**Hillside Farm, EskdalesideNYM/2011/0685/FL**

Project:  
Alterations to Hillside Farm, Sleights, North Yorkshire

Drawing:  
Proposed Site Layout

Date: 15/8/11	Scale: 1:200	Project No. ATA-2009-28	Drawing No. <b>04</b>
Drawn by: AHT	Revision: C.	Cod Ref. ATA-2009-28

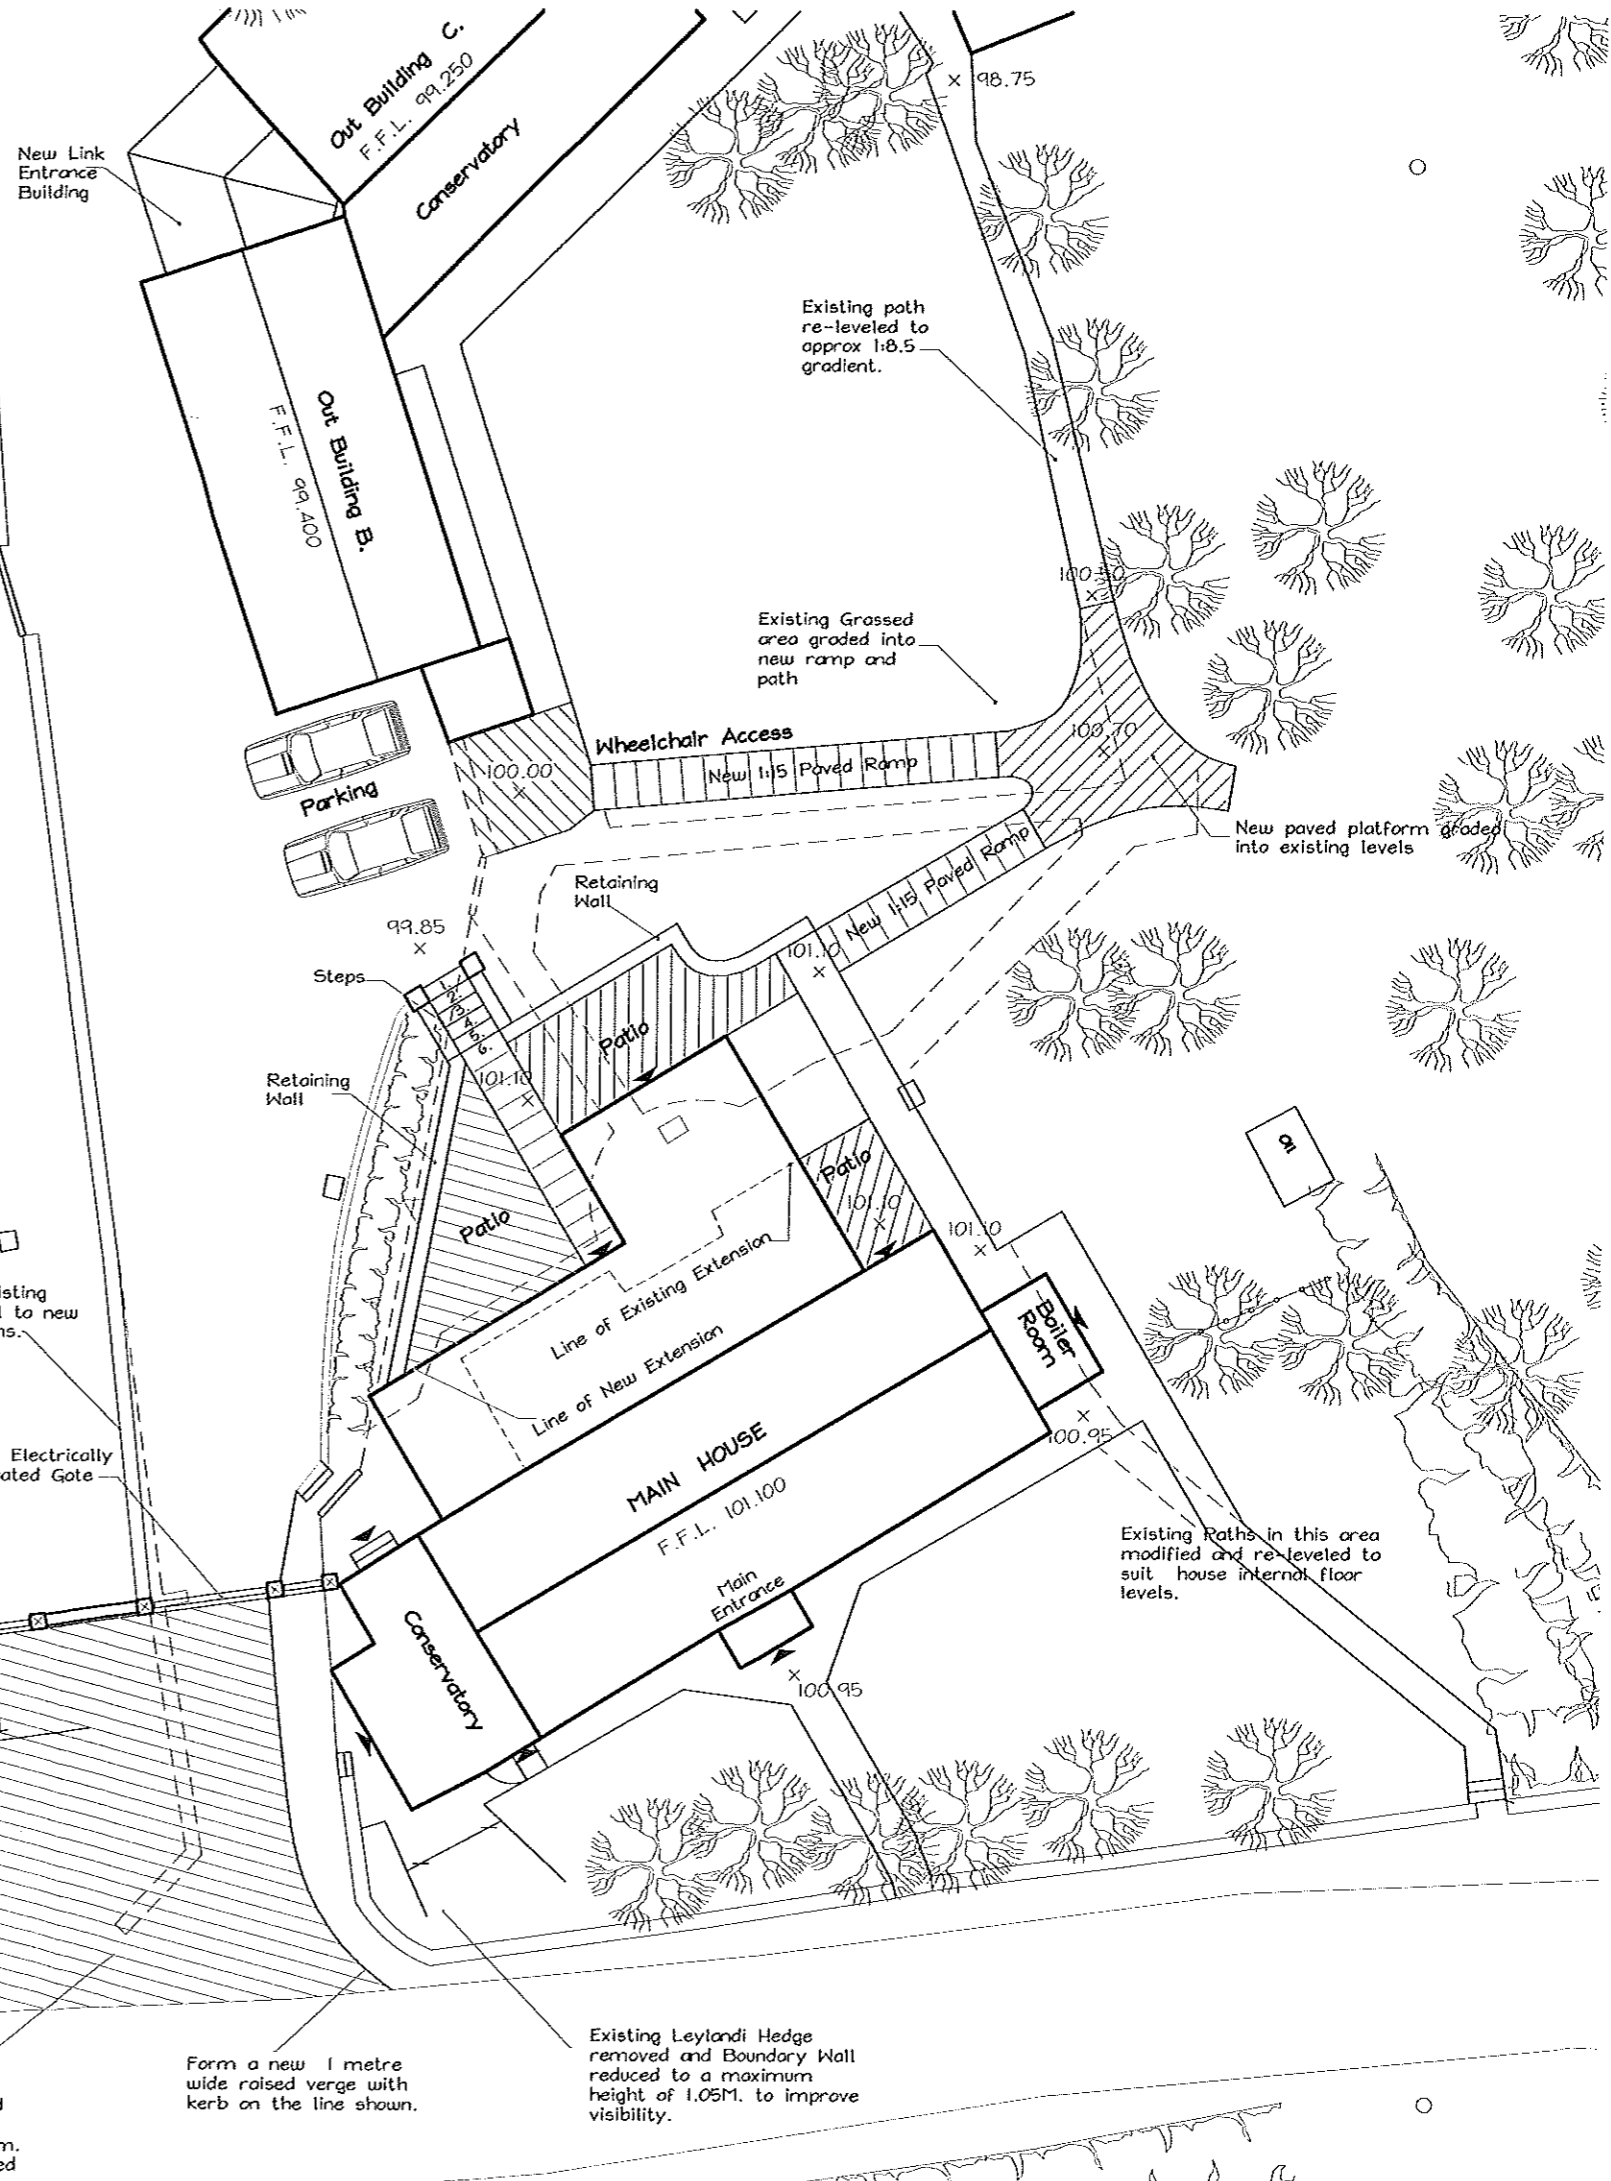
A	Minor amendments	3-9-11
B	Minor amendments	20-9-11
C	General amendments to Entrance Area	29-11-11
Revision	Details	Date

New surface drainage taken to kerb outlet and discharged into adjacent hedge line ditch.

Section of existing Hedge removed and replanted as shown to improve visibility.

Existing Field Gate repositioned and ground regraded around field entrance.

New Electrically operated Gate

Re-align existing dividing wall to new gate positions.

New paved Entrance Area modified to improve safety for vehicular entry and exit. Formed with 100mm. crusher run with binding agent on approved 250mm. Sub-base laid on well consolidated

Form a new 1 metre wide raised verge with kerb on the line shown.

Existing Leylandi Hedge removed and Boundary Wall reduced to a maximum height of 1.05M. to improve visibility.
